# STAFF REPORT

## REGIONAL CENTER HEARING EXAMINER - HIGH IMPACT CASE

<b>Case Number</b>	2026-REG-029
<b>Address (approx.)</b>	1140 Dr. Martin Luther King, Jr. Street
<b>Location</b>	Center Township, Council District 12
<b>Petitioner</b>	Indianapolis Public Schools, by Russell McClure
<b>Zoning</b>	SU-2 (RC)
<b>Request</b>	Regional Center Approval to provide for a proposed multi-purpose building for health and wellness, including a gymnasium, and for two bleacher structures to accommodate up to 2,000 persons at an outdoor recreational facility, plus an outdoor educational and public amenity space.

Site Plan and Landscape Plan, file-dated 2/20/2026

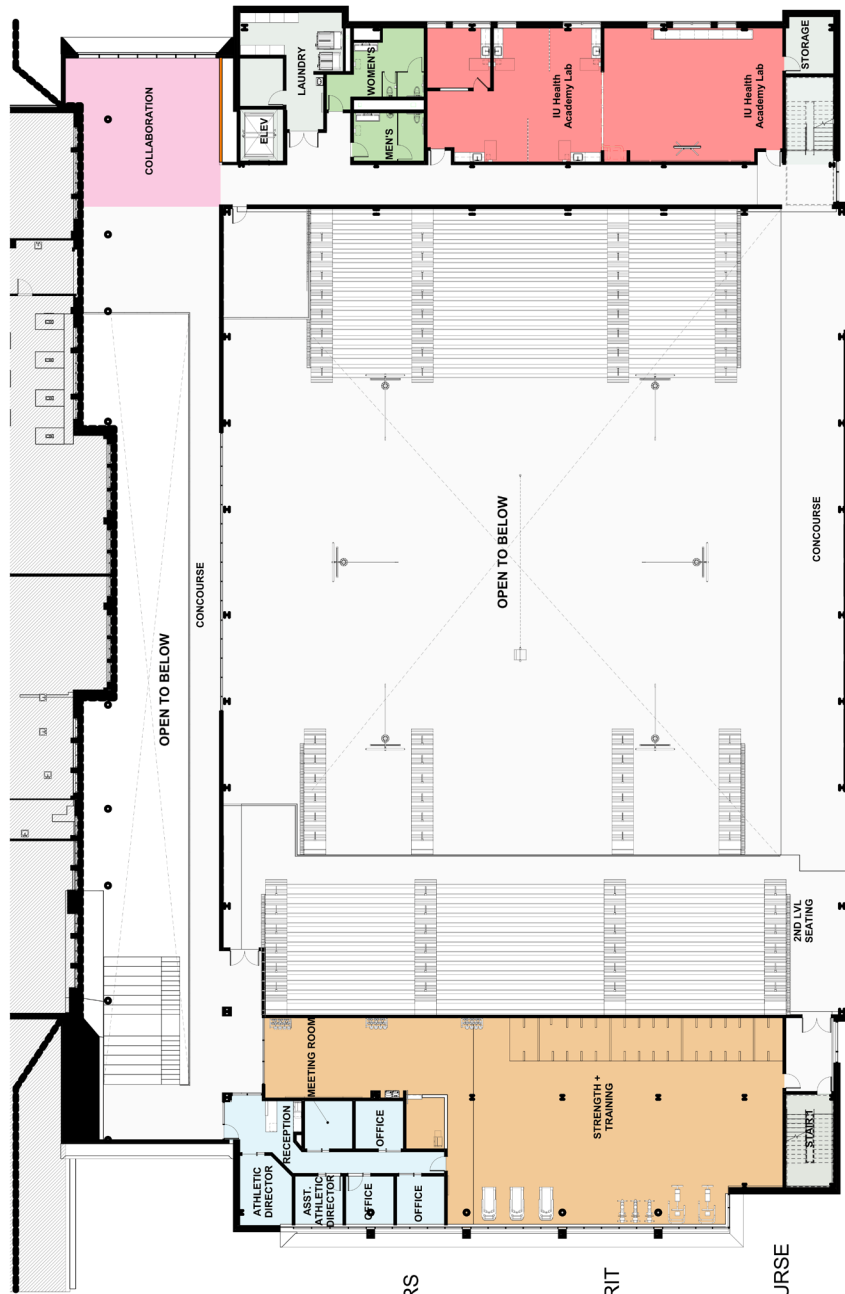
2. The landscaping plan submitted to the file did not include calculations to review for compliance with the landscaping standards outlined in Chapter 744. Article V of the Zoning Ordinance, including interior parking lot landscaping. *An updated landscaping plan for the site with the relevant calculations shall be submitted and subject to planning staff review and approval, prior to the issuance of an Improvement Location Permit.*
